APPLICATION GUIDE FOR
TRUNK CARRIER SPECIFICATIONS
REA FORM 397b

Purpose: The purpose of this addendum is to clarify certain items in the REA Form 397b and to offer some suggestions in being more specific in your carrier system requirements.

FIGURE 1 - SIMPLIFIED DIAGRAMS OF E&M SIGNALING

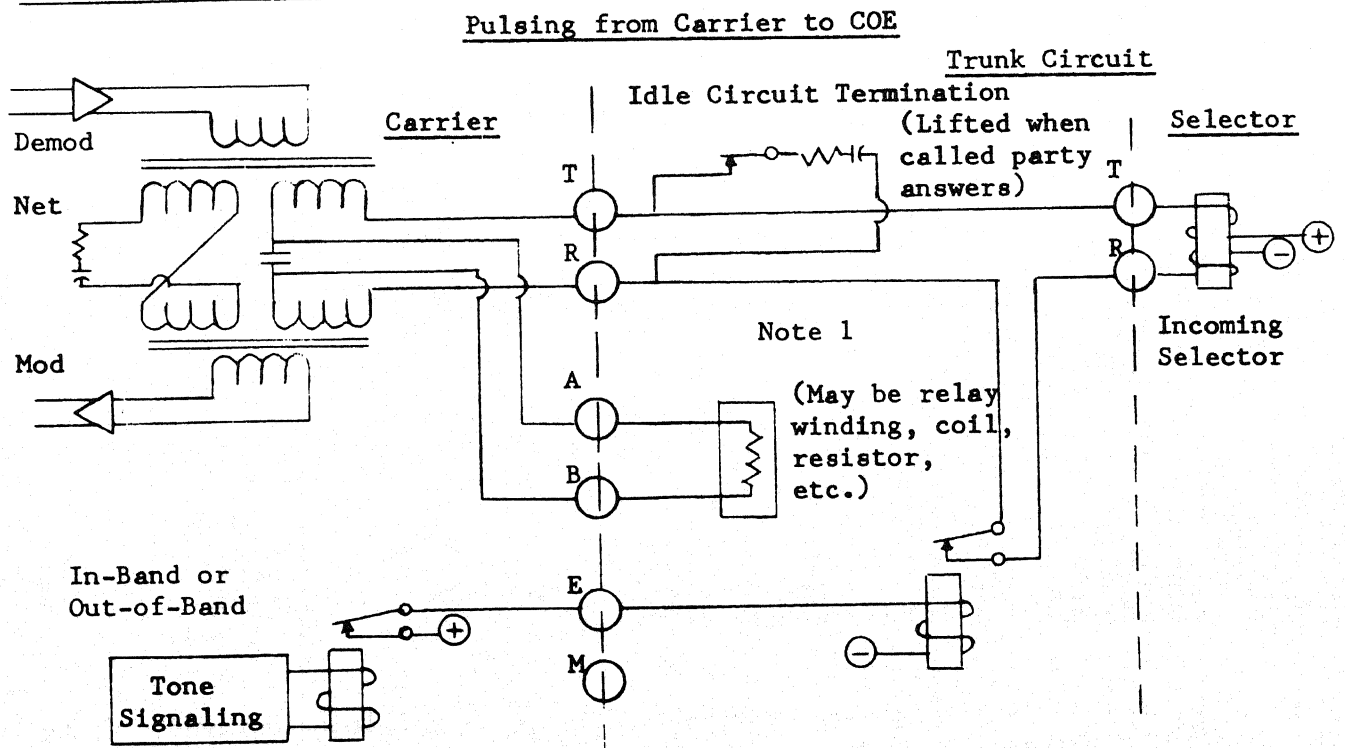
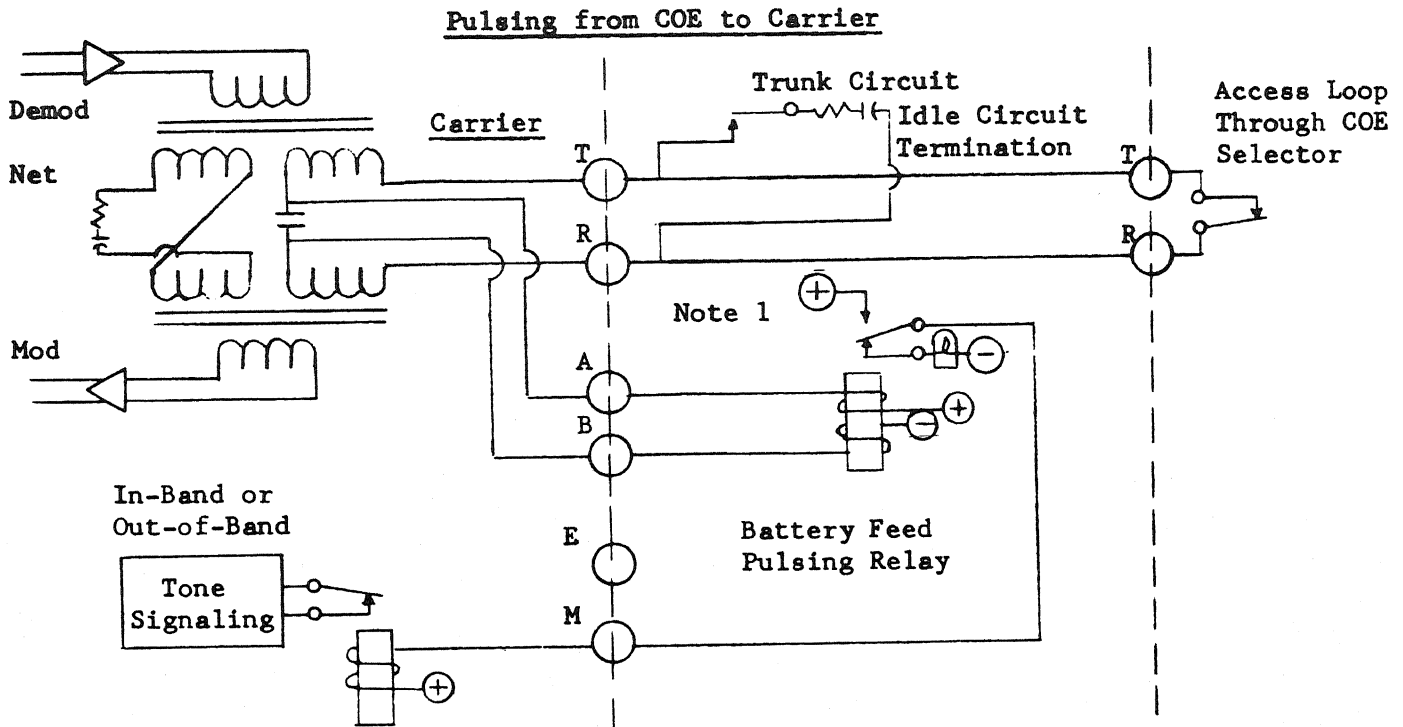
2.061 In Item 2.091 is specified the requirement for A and B leads on E and M signaling terminations for the carrier channels where no VF extensions are required. Figure 1 is a simplified drawing of E and M signaling which indicates a common method of deriving A and B leads when E and M trunk circuit is connected to a coil type hybrid. When a resistance type hybrid is used instead of a coil type, A and B leads can be derived as shown in Figure 2 by using coils to isolate the pulsing relay from the voice frequency transmission path. Either coil or resistance type hybrids can be used with carrier systems and meet all transmission requirements. The carrier supplier will derive the A and B leads where they are specified. A and B leads should not be derived by using repeating coils. It is intended that by specifying the need for A and B leads as part of the hybrid supplied by the carrier seller, the use of repeating coils will not be required. In this way improved echo return loss and singing point values should be possible and the insertion loss due to repeating coils is eliminated. It is important that the engineer preparing the carrier equipment plans and specifications coordinate the trunk equipment from the central office equipment supplier with that of the carrier equipment supplier to avoid difficulties at time of cutover.

FIGURE 3 - EXAMPLE OF LEVEL DIAGRAM

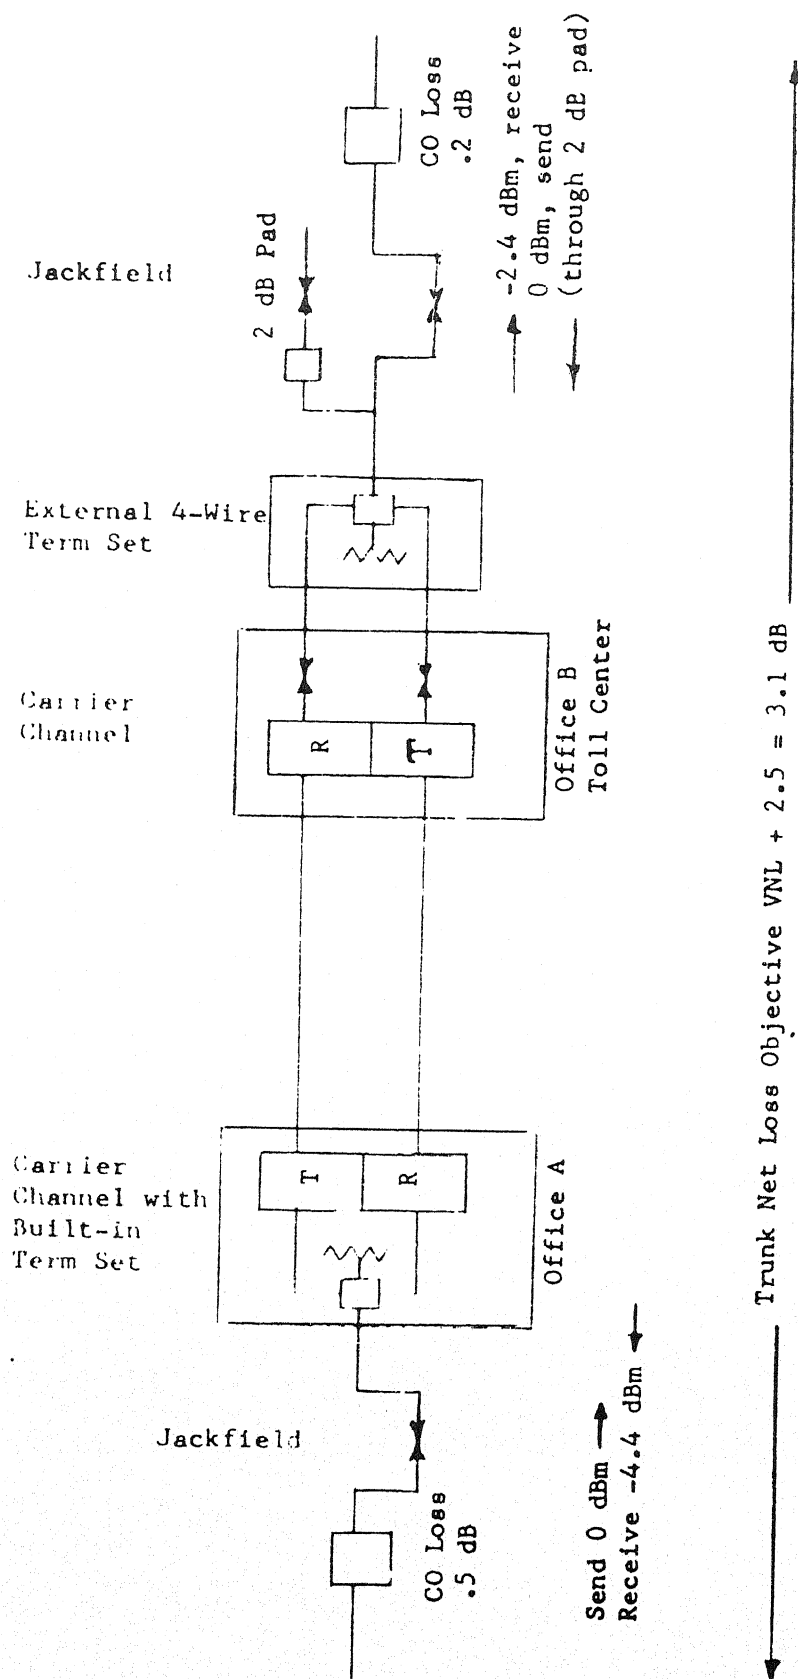
2.156 An example of a level diagram is shown in Figure 3.
